CITY OF PORTLAND, MAINE
PLANNING BOARD

RE: The Estates at Longfellow Inn. 130 Eastern Promenade
Chart: 3 **Block:** C **Lots:** 1 and 2
Application ID: 2007-0123

**THE ESTATES AT LONGFELLOW INN
130 EASTERN PROMENADE**

SITE PLAN AND SUBDIVISION REVIEW

Image 2- Existing garage to be demolished

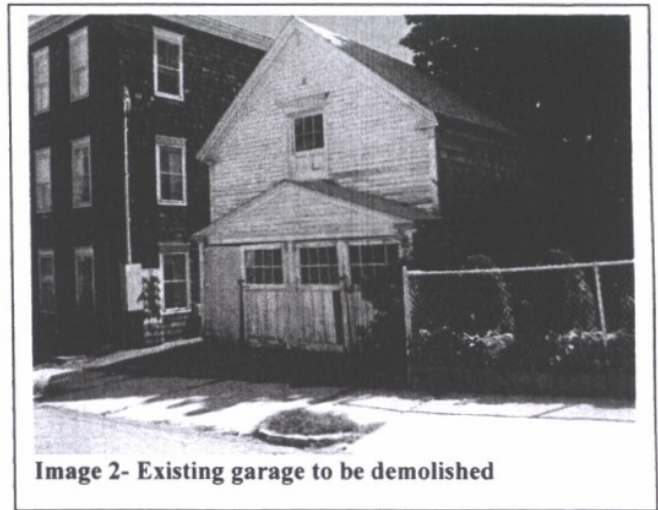
The applicant is not required by zoning (Section 14-332) to incorporate additional parking into their proposal because the proposal does not increase the number of units. The only requirement is that they not reduce off-street parking to less than what exists currently. At present, the property can accommodate approximately two parking spaces in the existing garage. The applicant proposes to increase off-street parking to seven (7) parking spaces, providing one parking space for each unit.

Image 5- Esplanade at intersection of Wilson and Eastern Promenade.

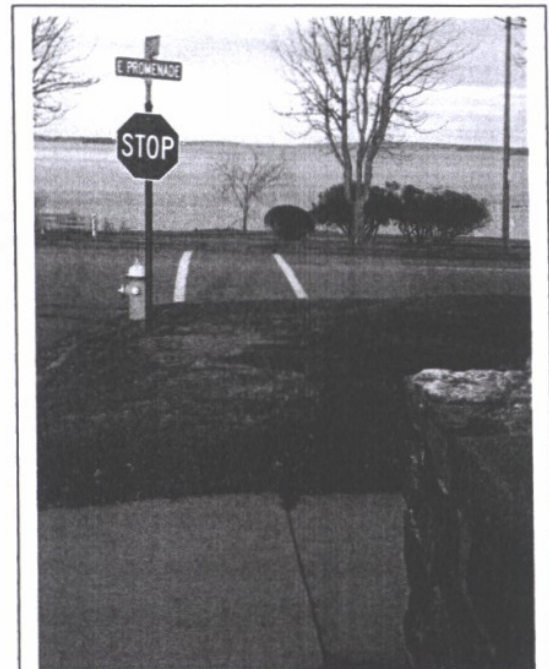
The applicant proposes to repair a portion of and to add street trees to the existing concrete sidewalk along Wilson Street. Currently, there is concrete sidewalk on both sides of Wilson Street and along the frontage on the Eastern Promenade. There is a crosswalk across the E. Prom on the right east side of Wilson Street, however there is no sidewalk linking to it across the Prom's grass esplanade. With the exception of the intersection at Moody Street and Eastern Prom, which has a similarly disconnected pedestrian system, all remaining intersections along the Prom (Congress; Turner; Quebec; Melbourne; Montreal and Walnut) include sidewalks along the edge of curb on the esplanade connecting to at least one crosswalk across the Prom (Congress Street has crosswalks on both sides).

Based on the above information, the applicant has revised their proposal to include new brick sidewalk connecting the sidewalk at Wilson Street to the crosswalk along Eastern Promenade. Public Works has reviewed the proposal to leave the existing sidewalk as concrete and determined that, so long as any disturbance is less than 10 feet and kept within two sections of concrete sidewalk, the disturbed area may be repaired with concrete. For a larger disturbance, the applicant must replace disturbed sections with brick sidewalk (see Attachment 8). This could apply for the proposed sewer connection on the Eastern Promenade side. The applicant proposes to dig pits on both sides and jack a pipe under the existing retaining wall and concrete sidewalk. The depth of the wall footing and the pipe elevation, however, remain uncertain until they actually dig into the ground.

The applicant has included this requirement as a note on the plans.
